KIRKSVILLE REGIONAL AIRPORT KIRKSVILLE, MISSOURI MODOT PROJECT NO. 24-028A-1

ADDENDUM NO. 3 TO

CONTRACT DOCUMENTS, SPECIFICATIONS AND PLANS FOR IMPROVEMENTS TO THE KIRKSVILLE REGIONAL AIRPORT KIRKSVILLE, MISSOURI MODOT PROJECT NO. 24-028A-1

SHEET NAME: ELECTRICAL LAYOUT PLAN

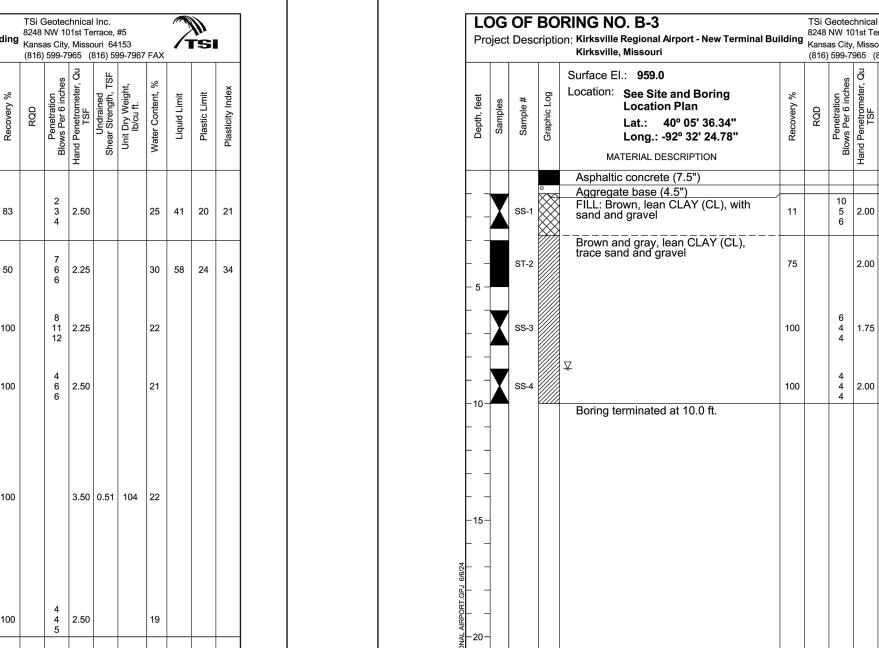
Revision: Removed marking. Revised callout for flagpole location. Revised parking lot light pole

locations due to striping/layout changes.

SHEET NAME: BORE LOGS

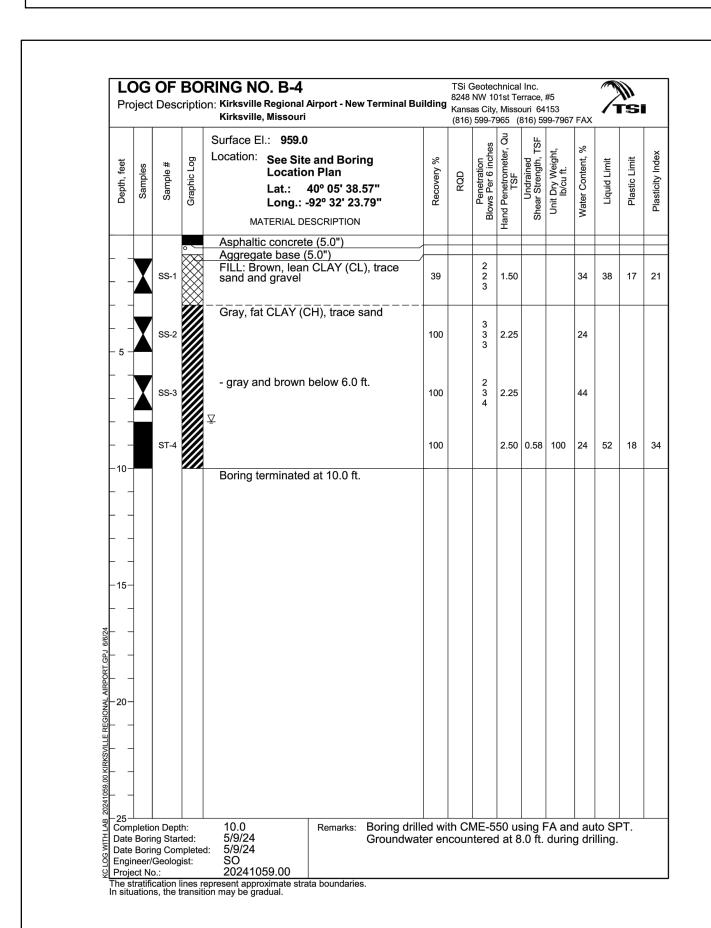
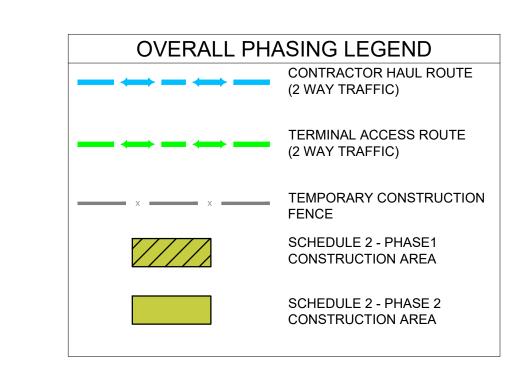
Revision: Added final boring logs (no longer stamped "draft"). **Justification:** Necessary for final understanding of underlying soils.

SHEET NAME:
CONSTRUCTION
PHASING PLANS
SCHEDULE II - PHASE 1
AND 2

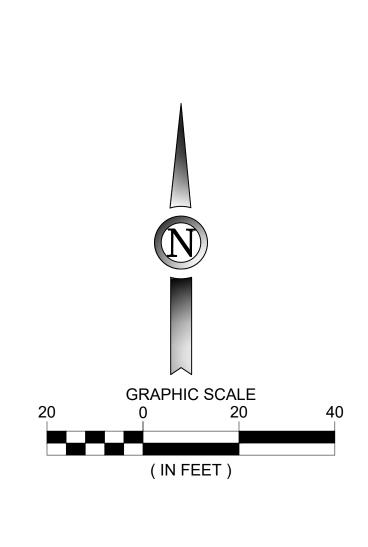
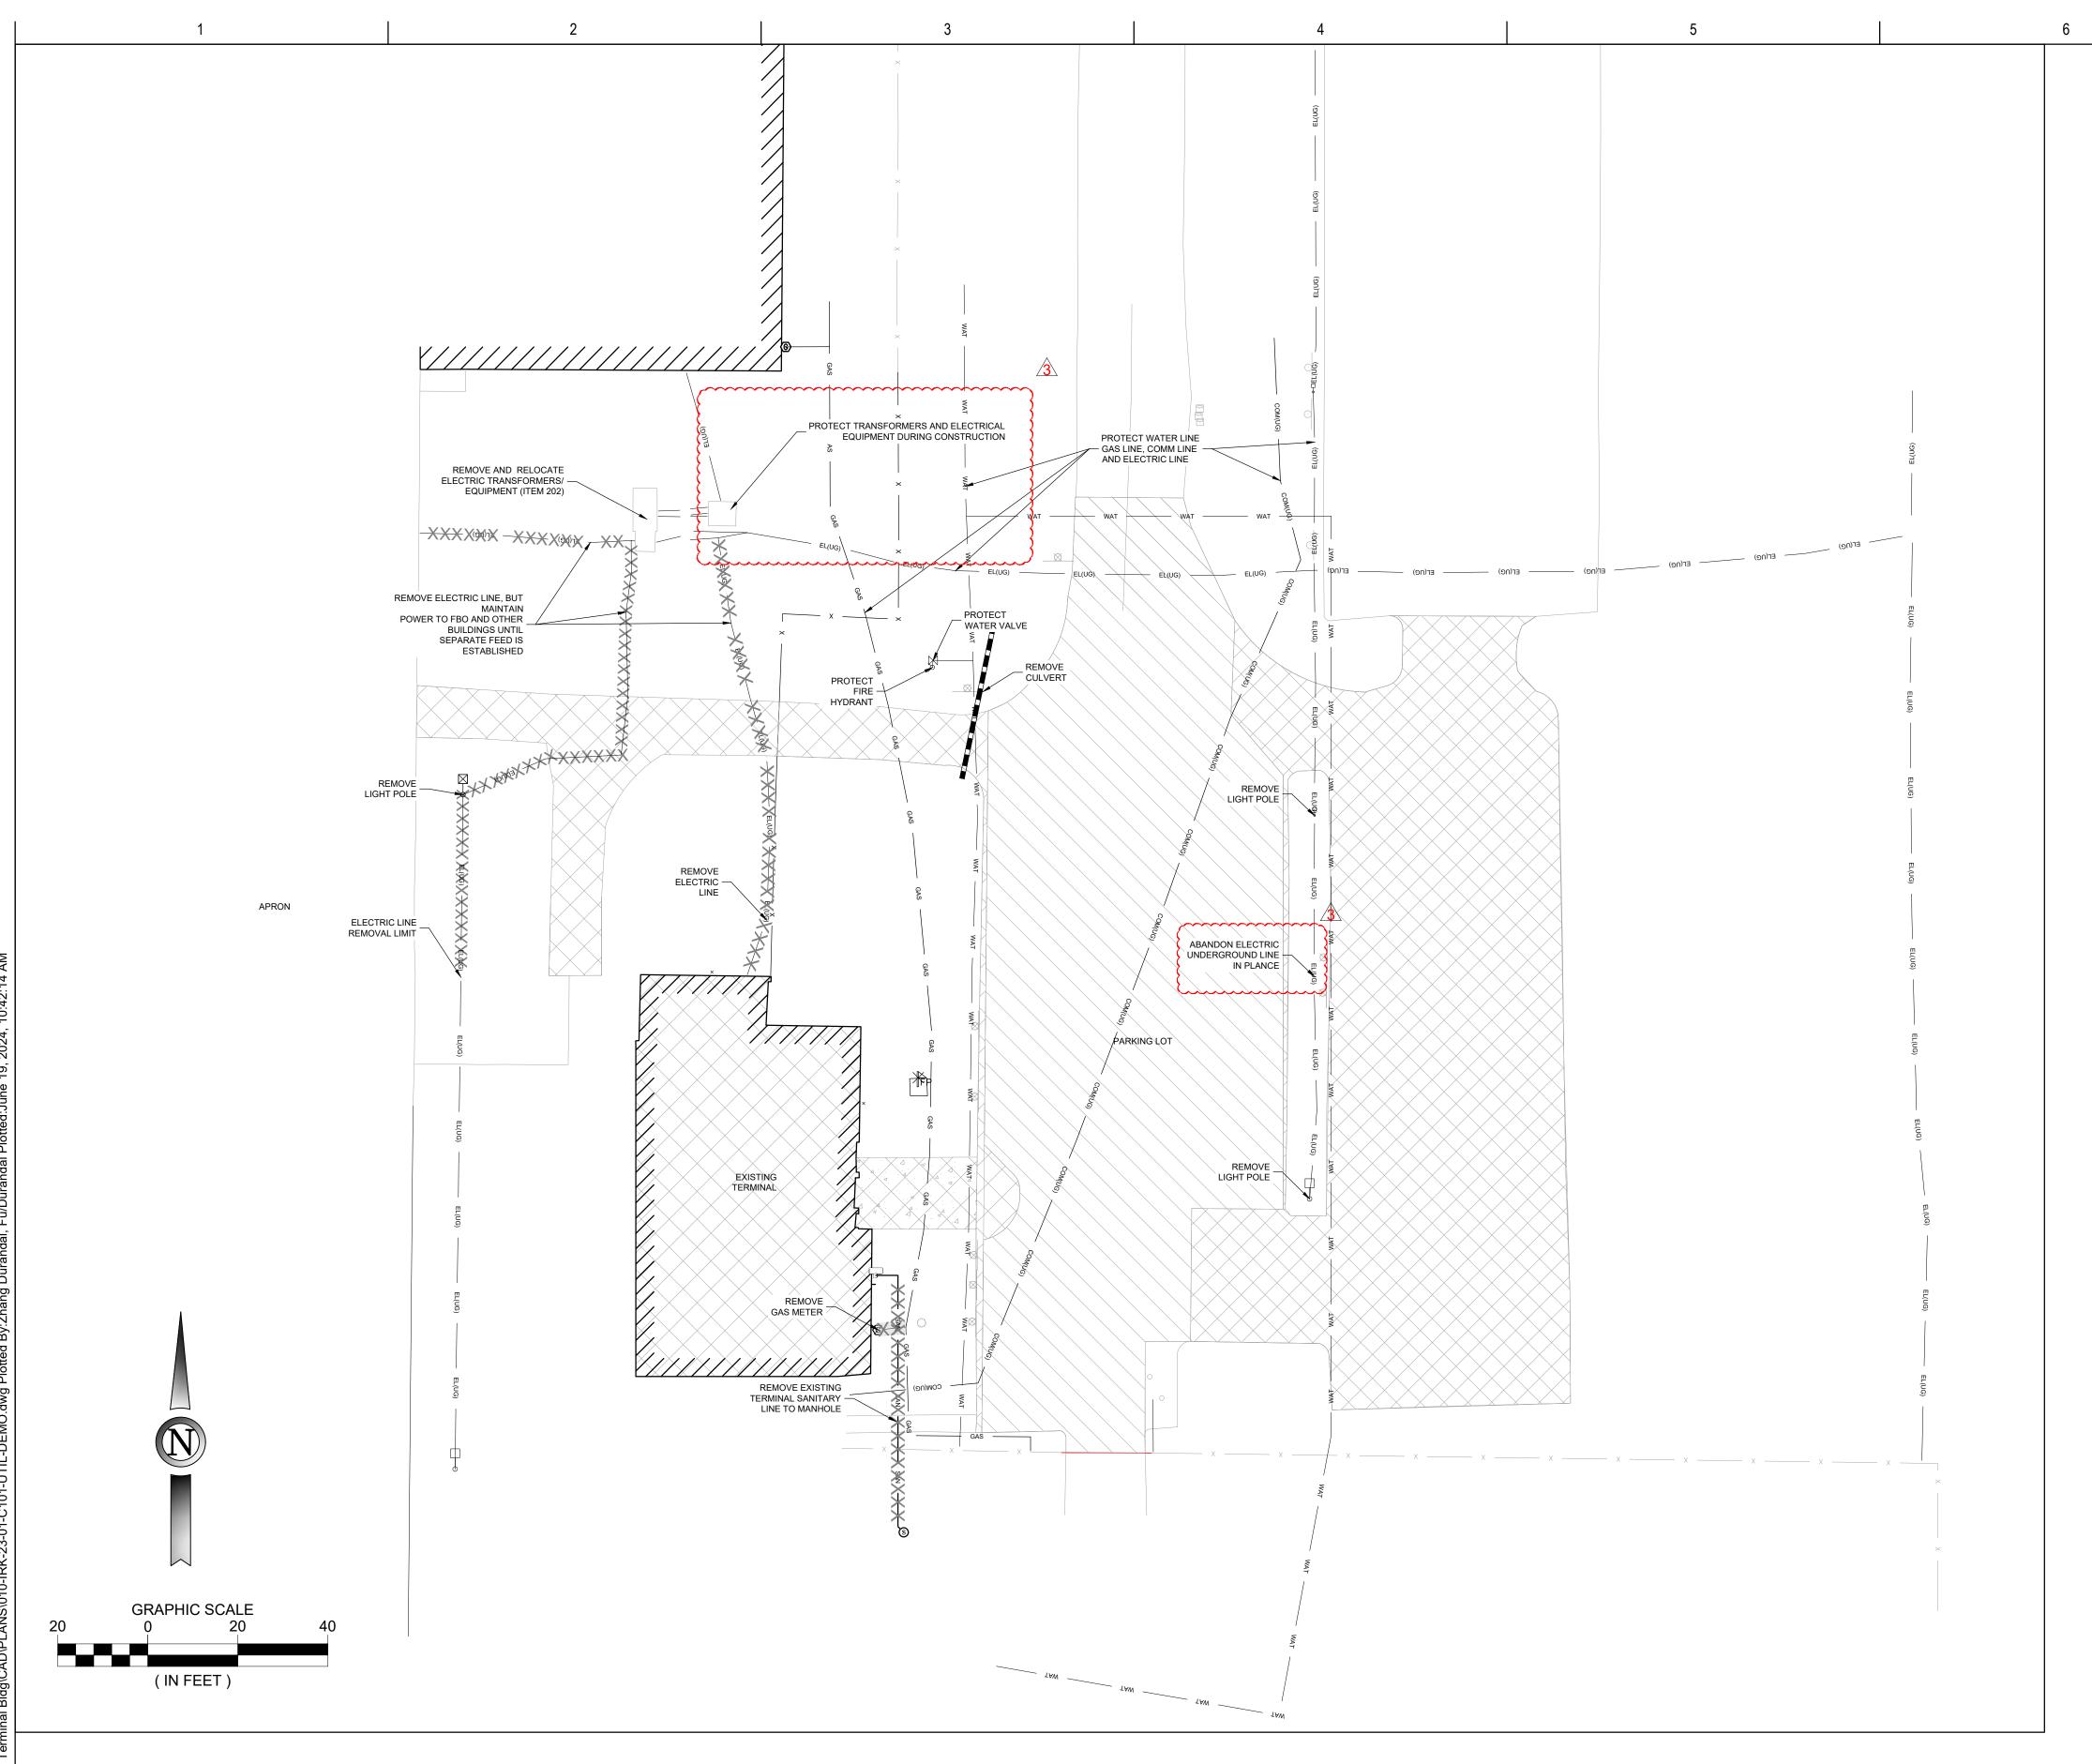
Revision: Modified note for temporary access to northeast parking lot to make it clear the access will be

asphalt pavement.

SHEET NAME: SITE UTILITY DEMOLITION PLAN

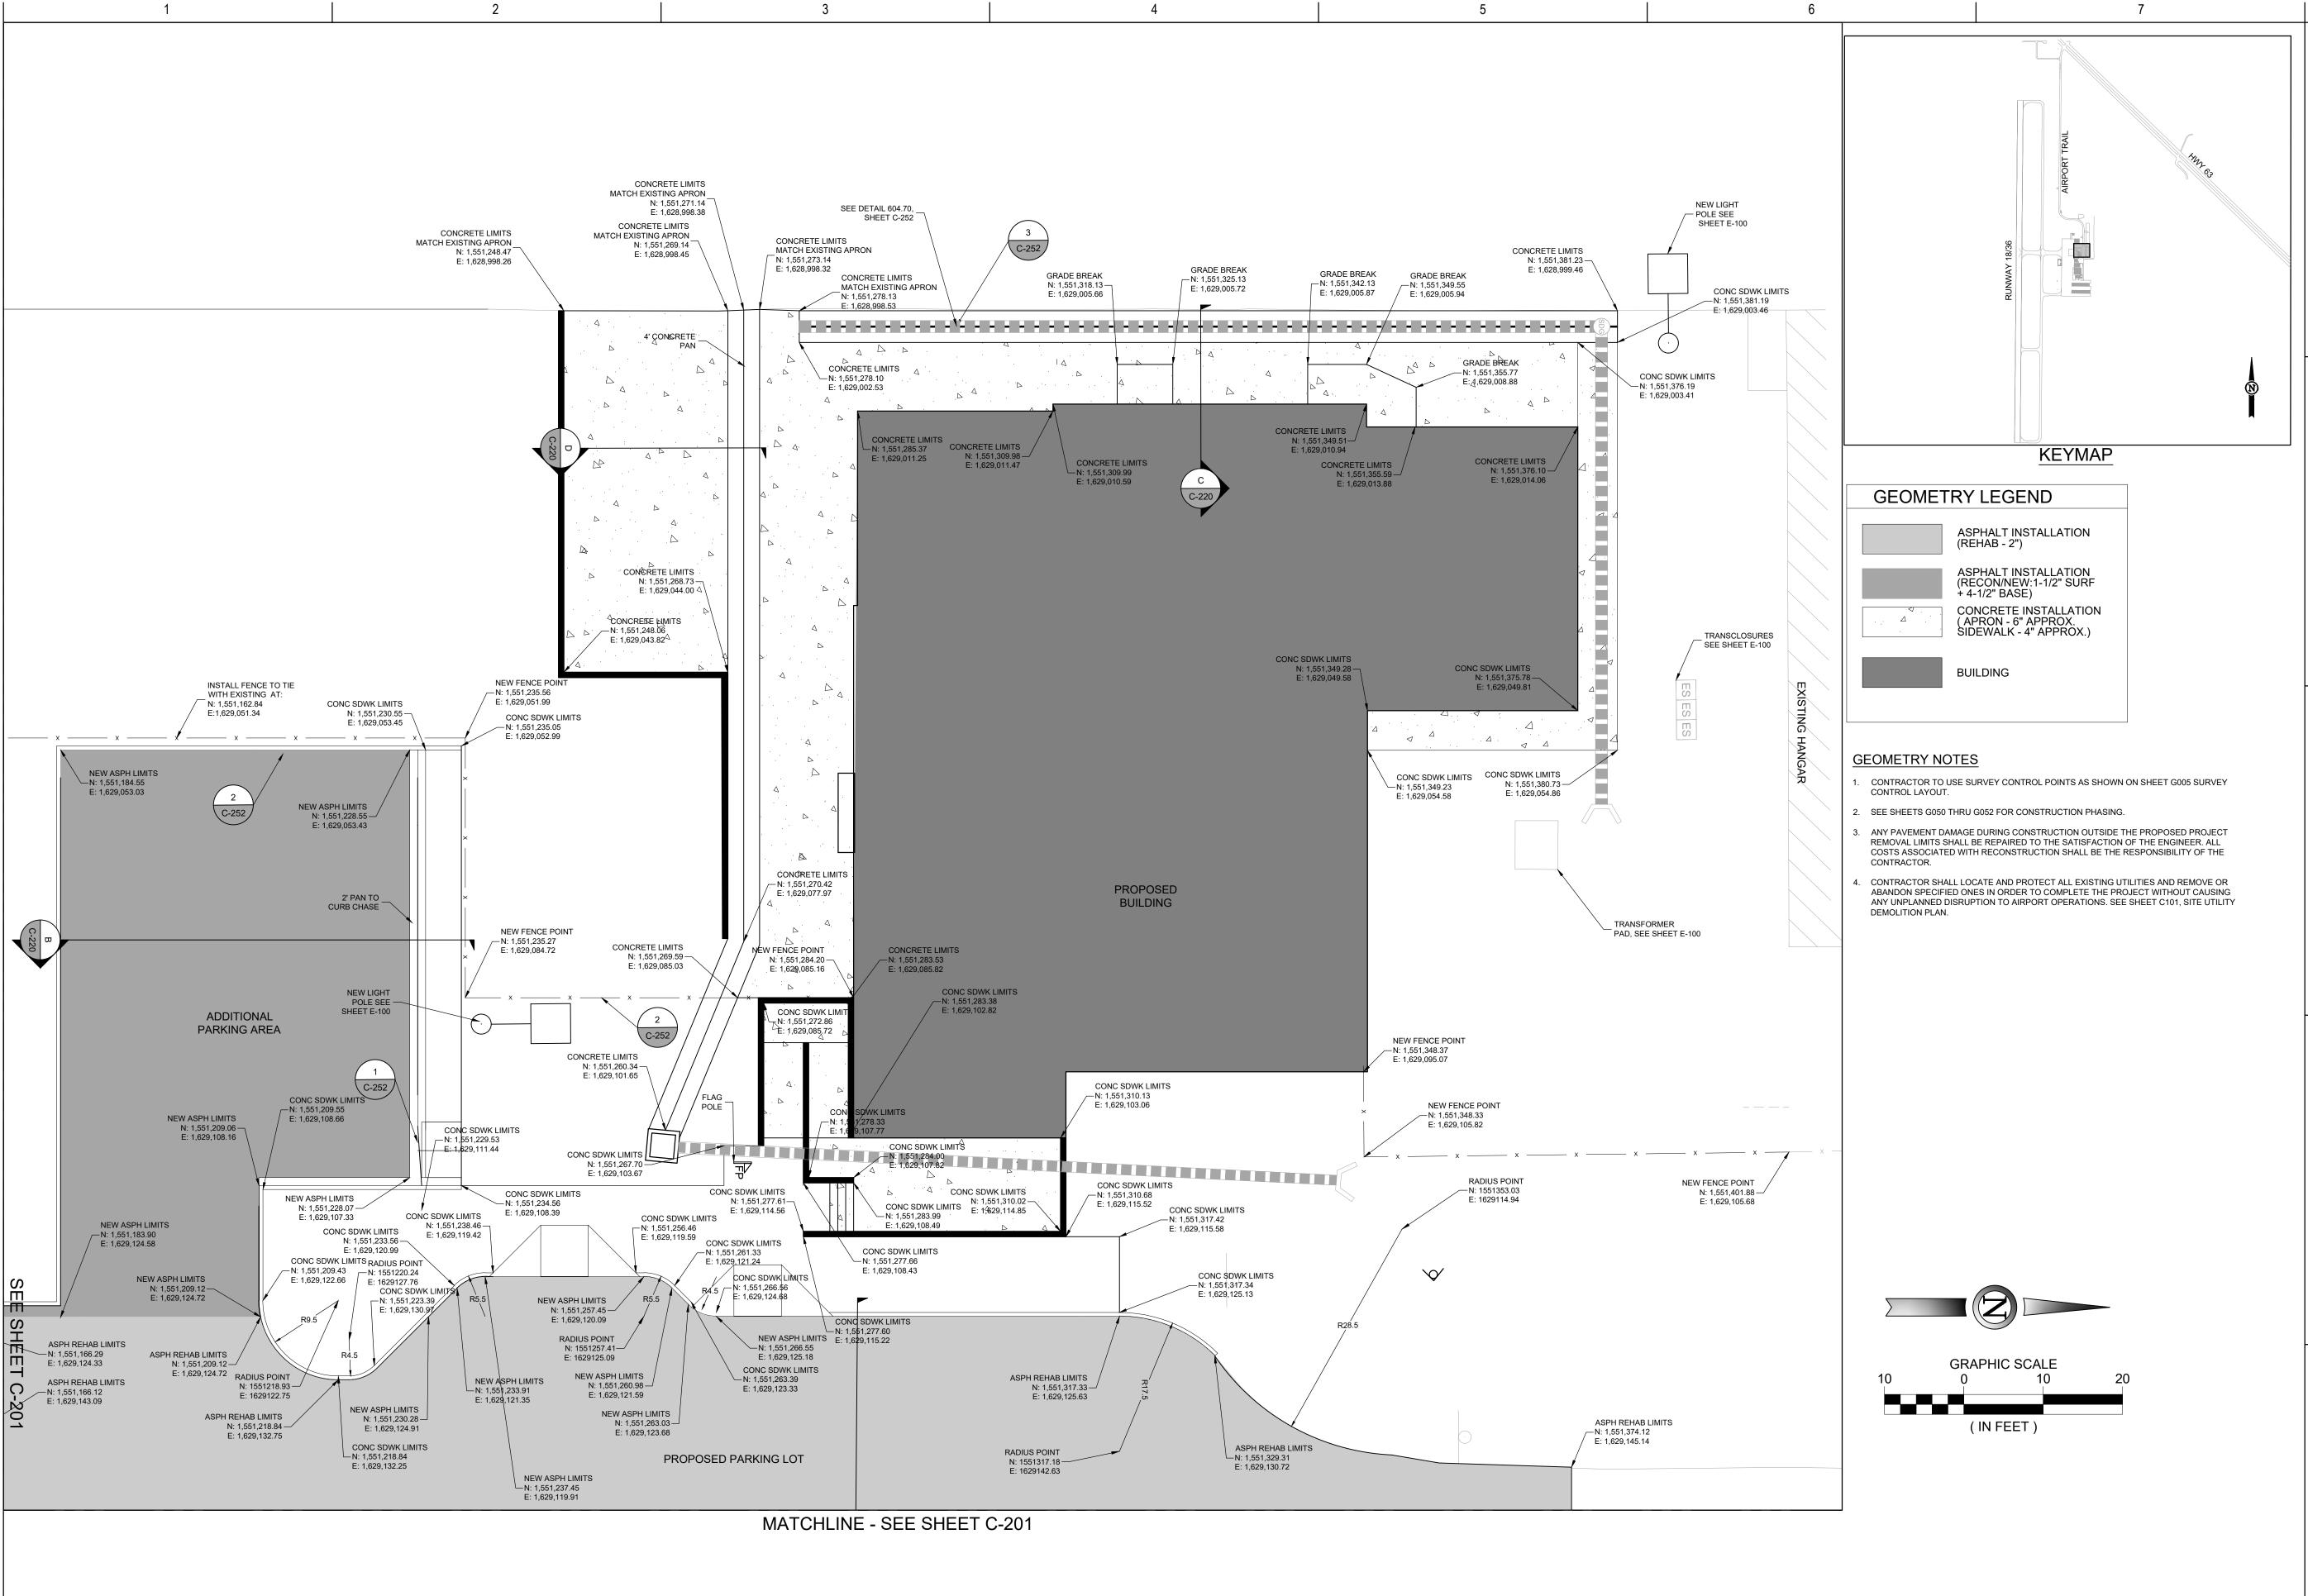
Revision: Indicate underground electrical in east parking lot servicing the existing light poles is to be

removed or abandoned in place. Call out transformer equipment to be protected in place.
